Addendum No. 1

LED Street Light Replacement Project Contract No. A-362

is hereby issued by the Town of Danville as follows:

STREET LIGHT MOUNTING BRACKET

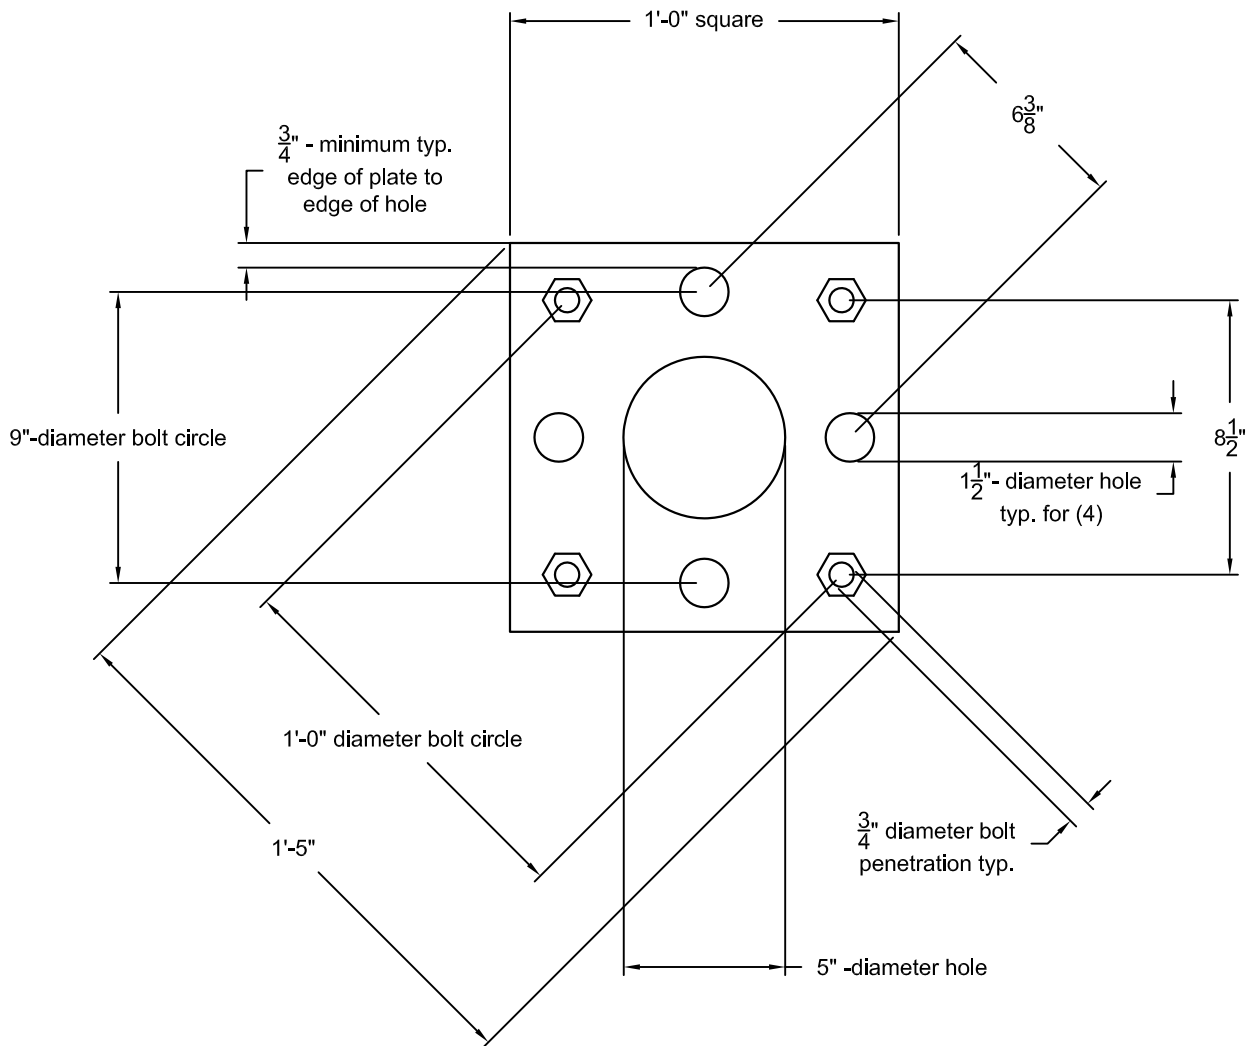
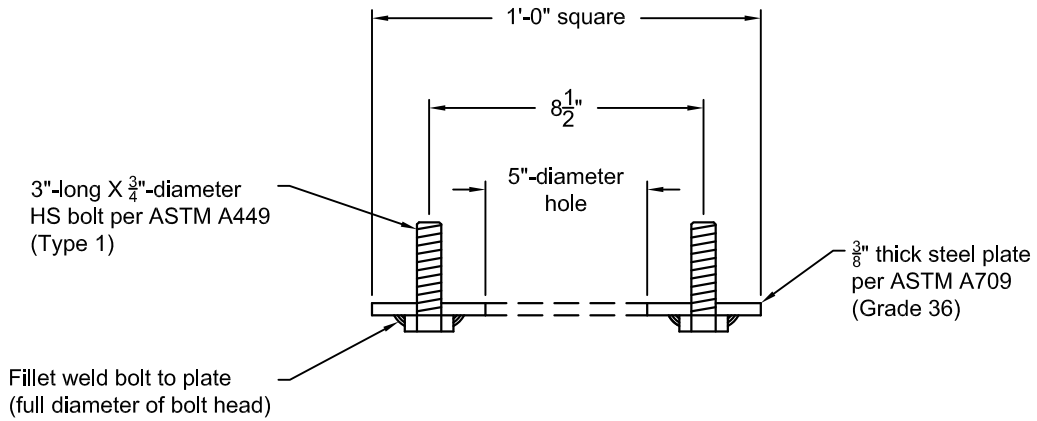
1. Add the Street Light Mounting Bracket detailed information sheet to the last page in Appendix A - Plans.

1. Replace page 27 of the specifications with the revised page 27 attached. Only 22 pole base adapter plates will be provided by the Town. Contractor shall obtain 10 pole base adapter plates as part of this project (See bid item #5).

9"-diameter bolt circle to 12"-diameter bolt circle conversion

The existing light post replacement with Holophane Wadsworth Poles over existing base may require base adaptor plates, partially furnished by the Town (22 available). These base adaptors may be required depending on the bolt pattern on some of the existing street light locations to be placed.

Since a precise quantity for base adaptors is unknown, the contract may be required to manufacture additional base adaptors as detailed. Hardware necessary such as additional bolts and washer to attach base adaptors whether supplied by the Town or manufactured by the contractor, to be stainless steel or hot-dipped galvanized rated for exterior use and to be supplied by the contractor. This includes mortaring gaps at bases after installation.
